ADDENDUM 3

The following changes are effective immediately and shall be incorporated into the Contract Documents.

M:\2025\2001 - Napanee WPCP Upgrade\01 Draw - WPCP\01-01 Production\2001_C0100.dwg, Mar 03, 2025, 2:45pm BY: Kevin White

SCALE: 1:400	JOB NO: 22001
DESIGNED BY: J.B.	DATE: 2025/01/23
DRAWN BY: K.B.W.	DRAWING NO.:
CHECKED BY: J.B.	C0100

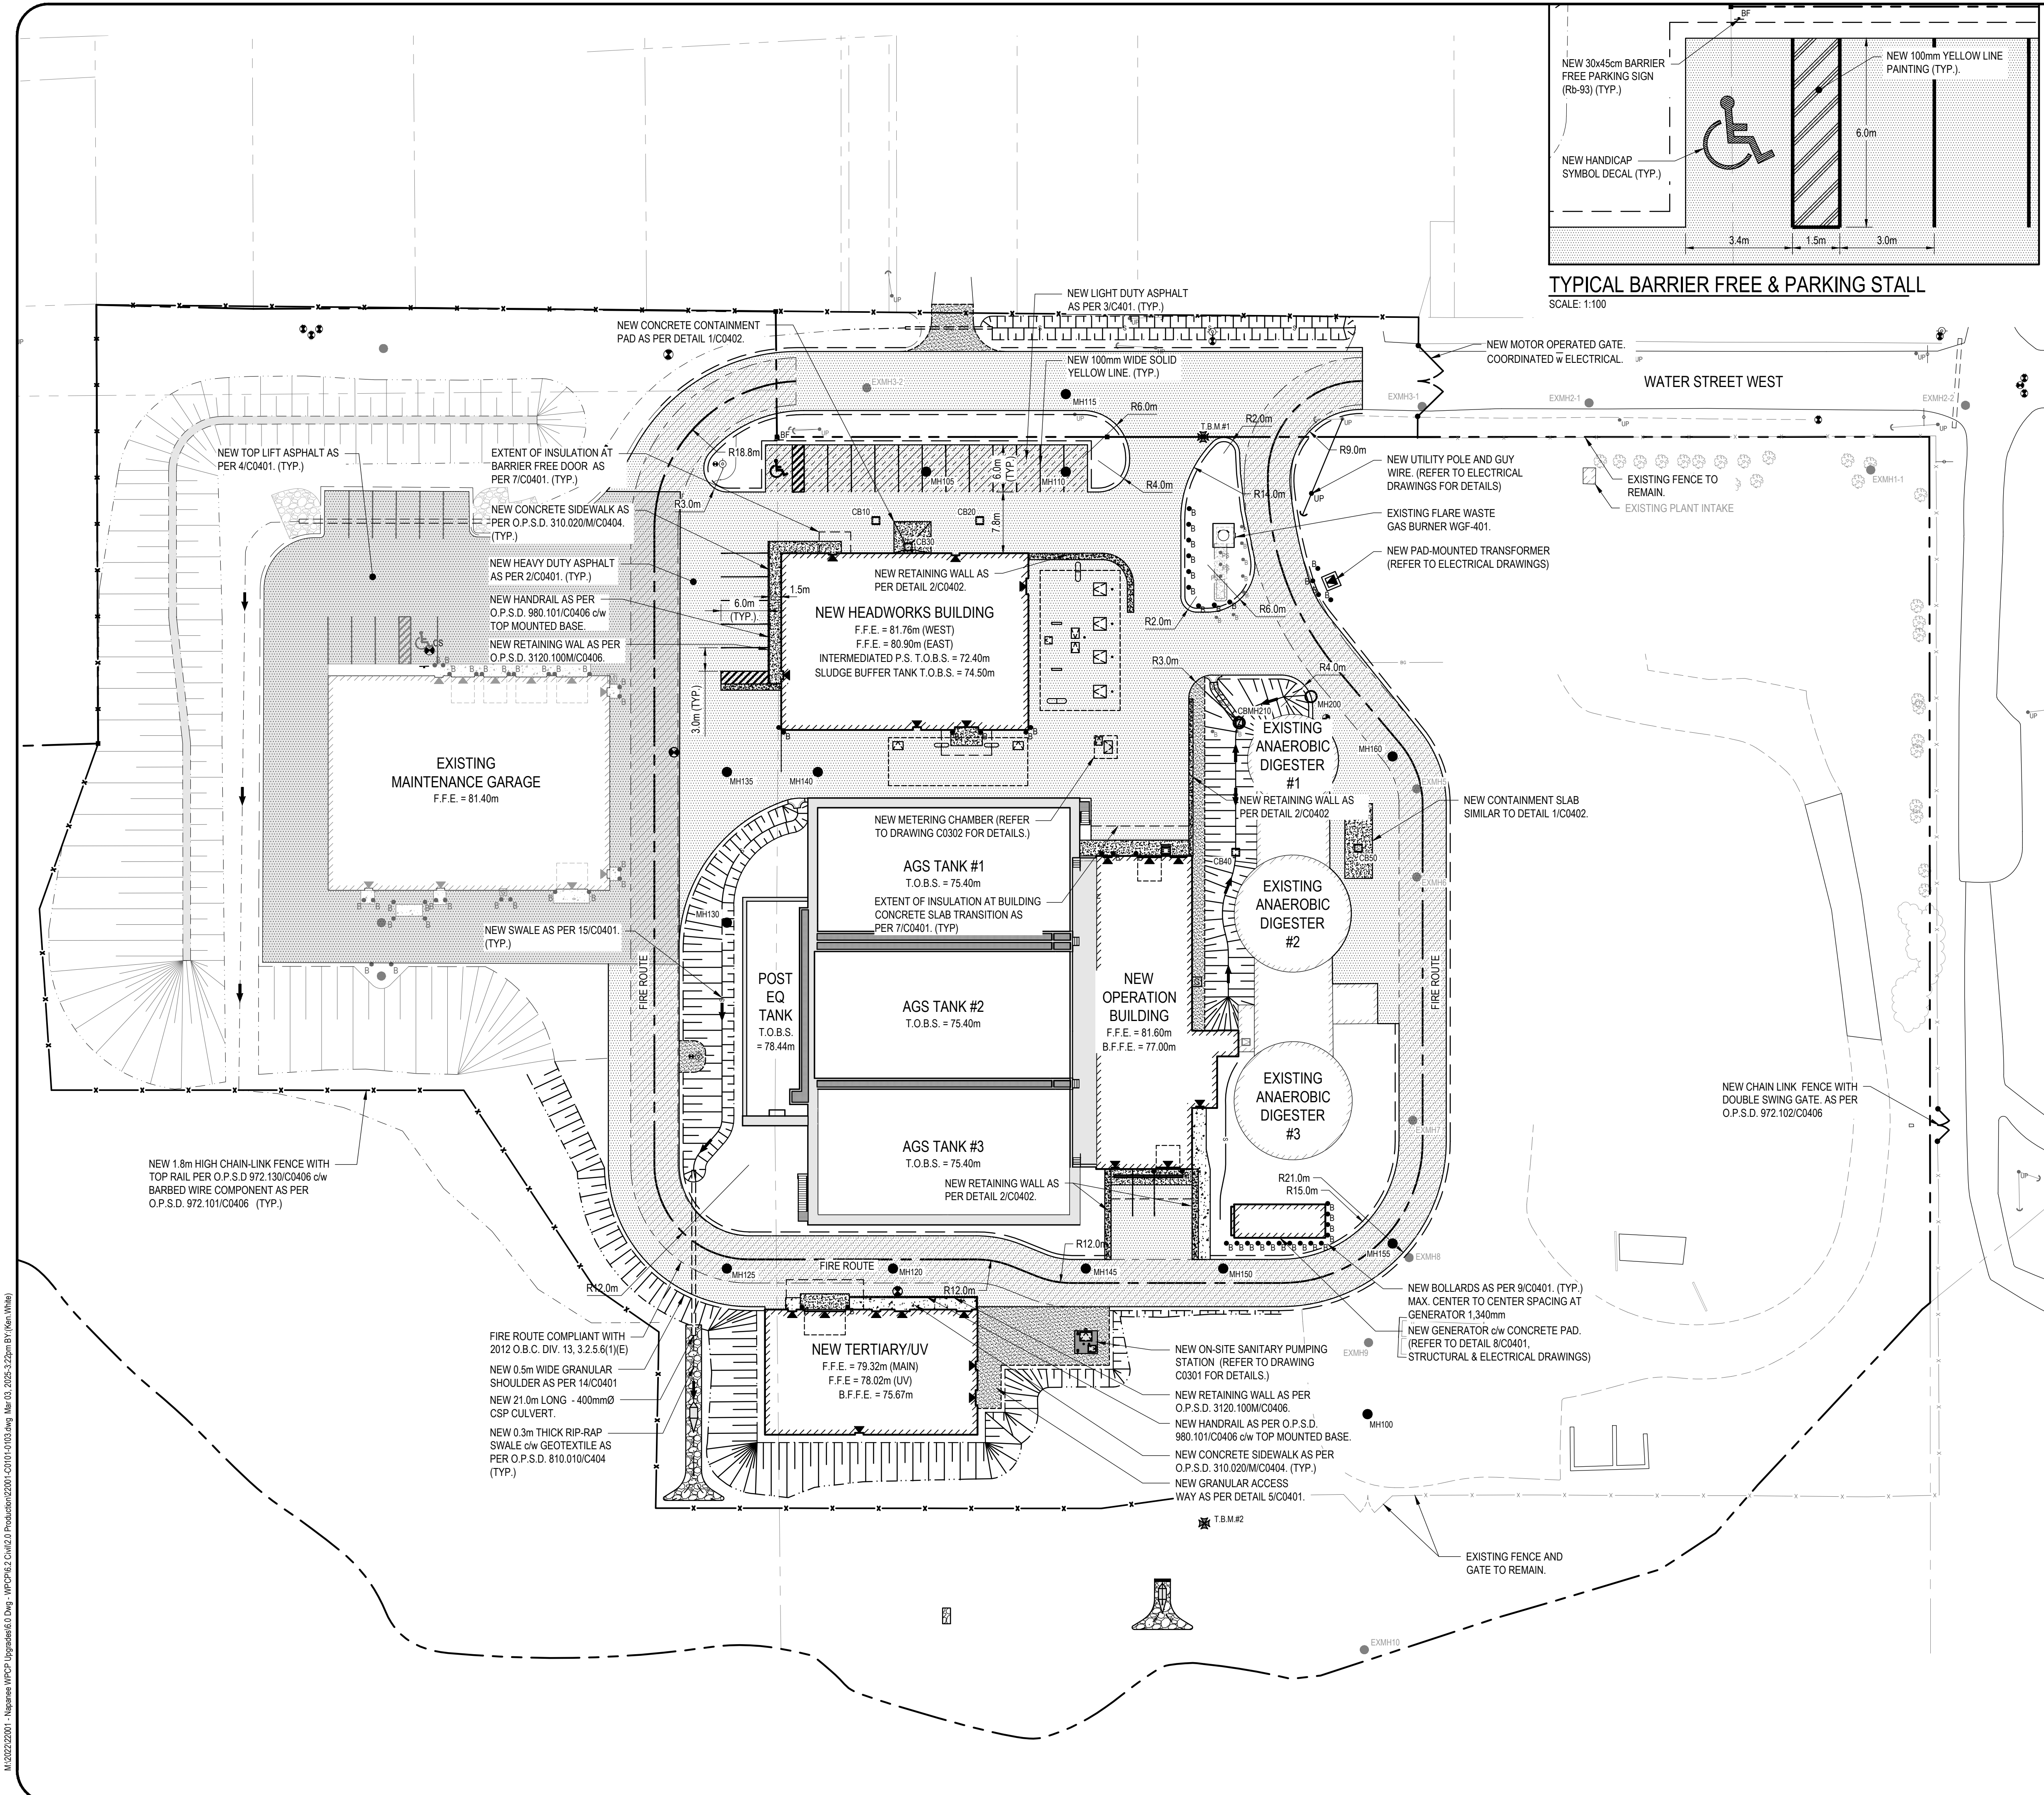
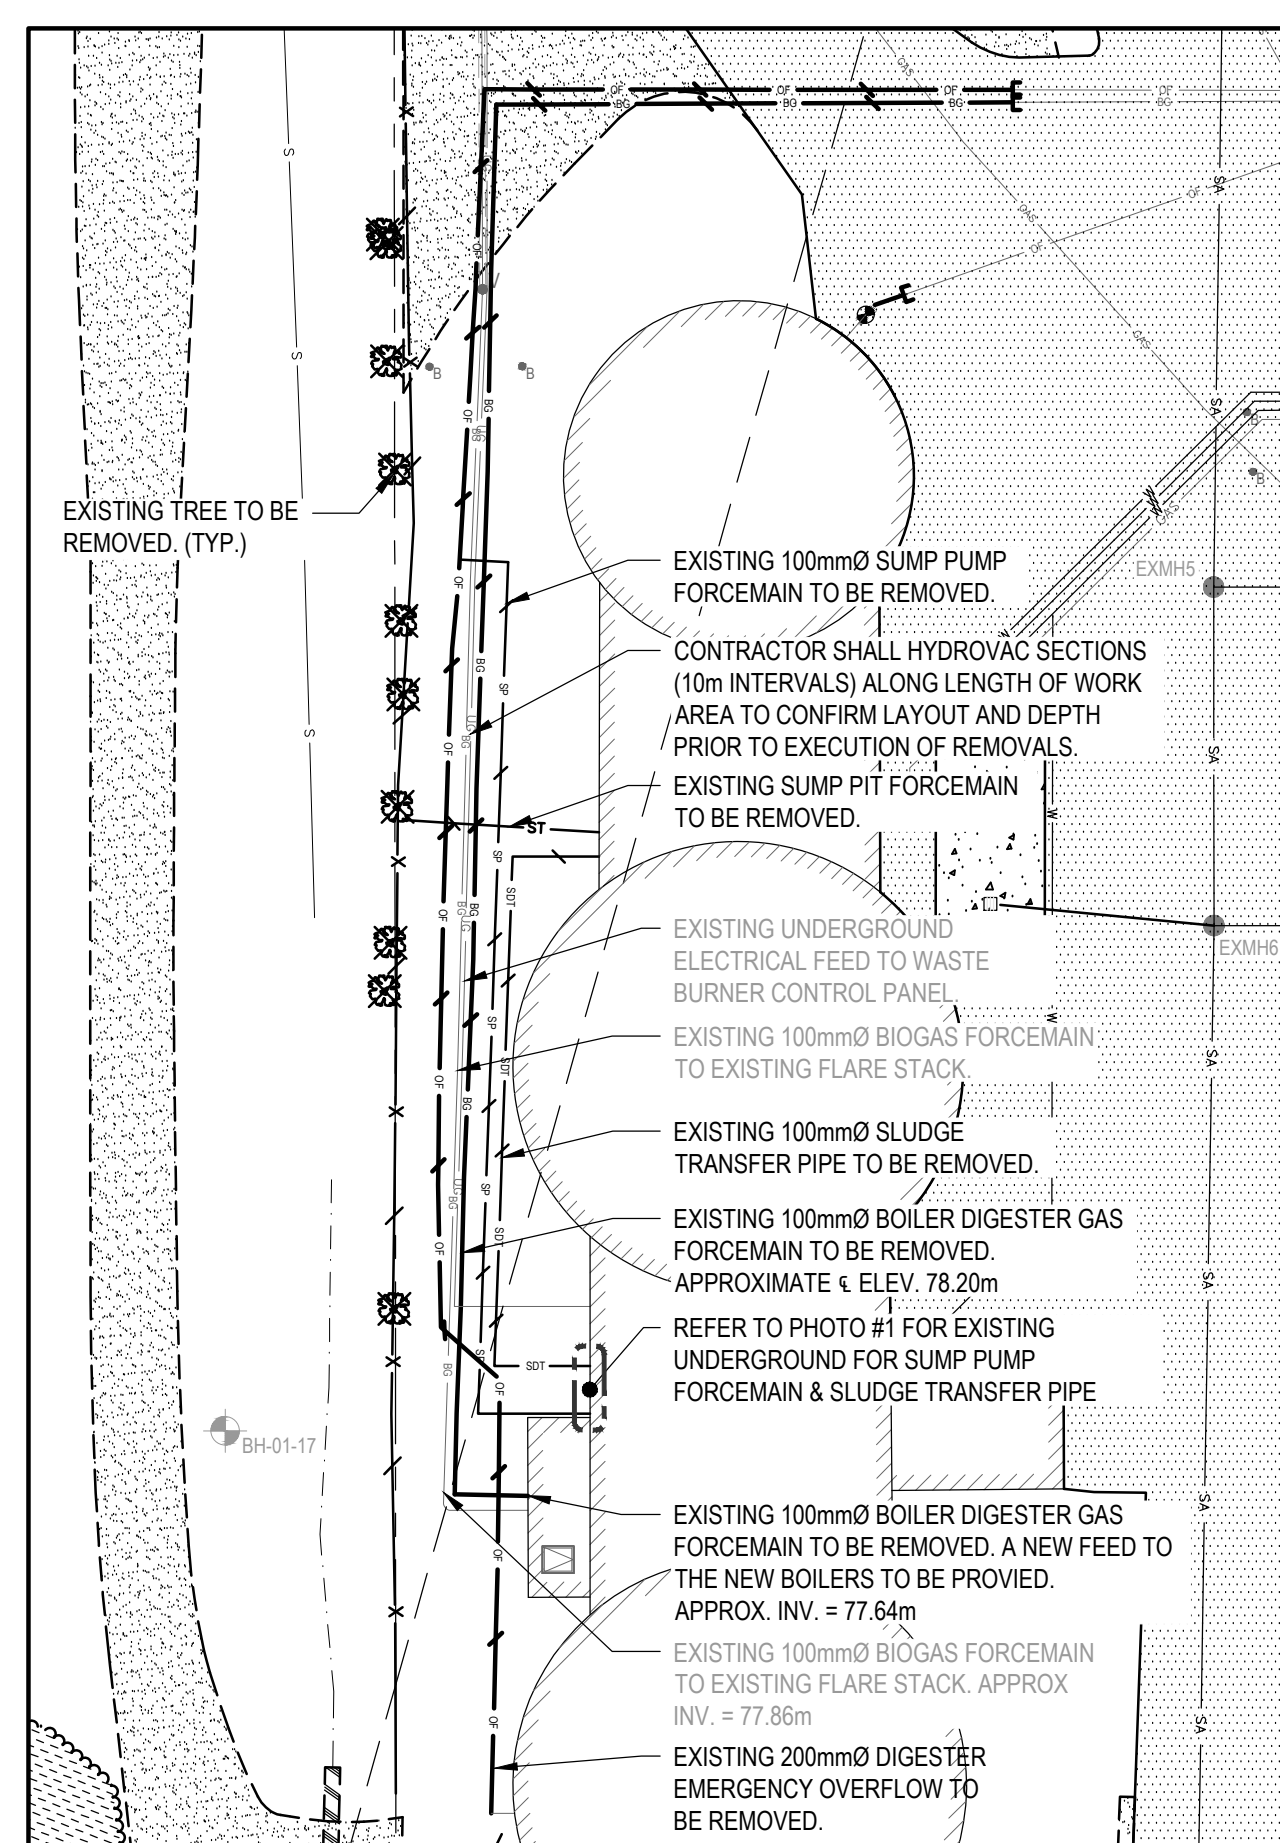
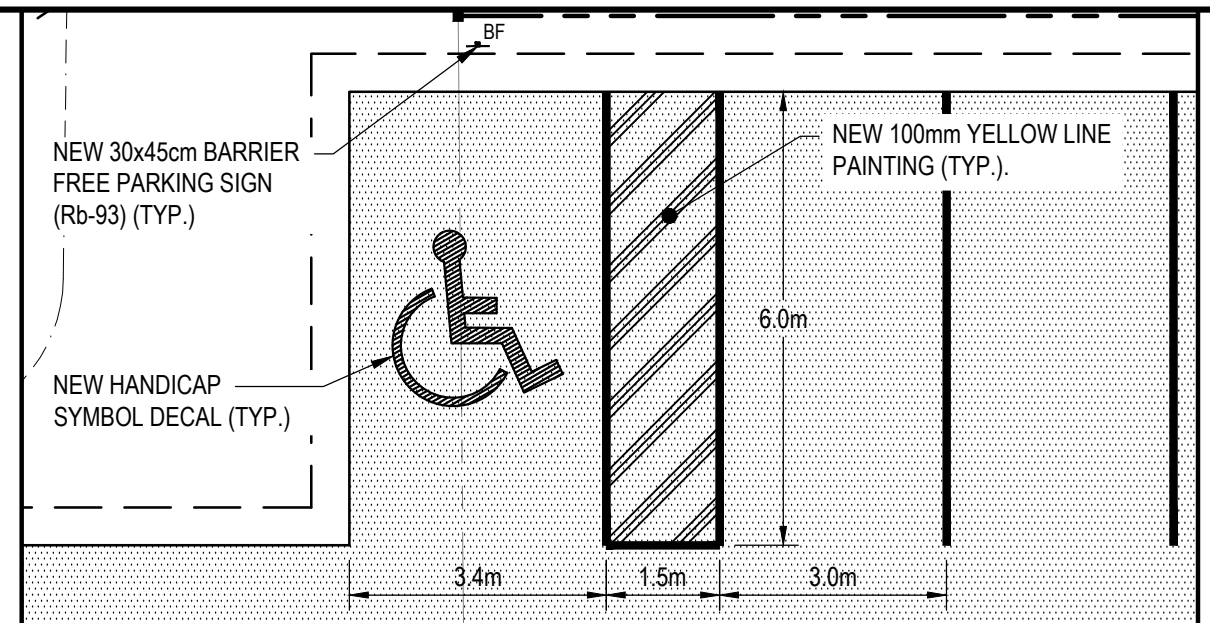
- .1 Drawing C0100
 - .1 **Amend** Drawing C0100 identifying the existing of existing tree coverage to the site plan.
- .2 Drawing C0101
 - .1 **Amend** Drawing C0101 identifying the extent to new perimeter fencing to be included in the contract.
- .3 Drawing 0201
 - .1 **Amend** CB10 to be a 1200mm diameter CBMH.
- .4 Drawing 0205
 - .1 **Amend** all references for DR2 to DR4.
- .5 Drawing C0301
 - .1 Amend the note “Wrap ~~SA1~~ **SS1** pipe using Desopol 60 tape at all buried location.(Typ).”
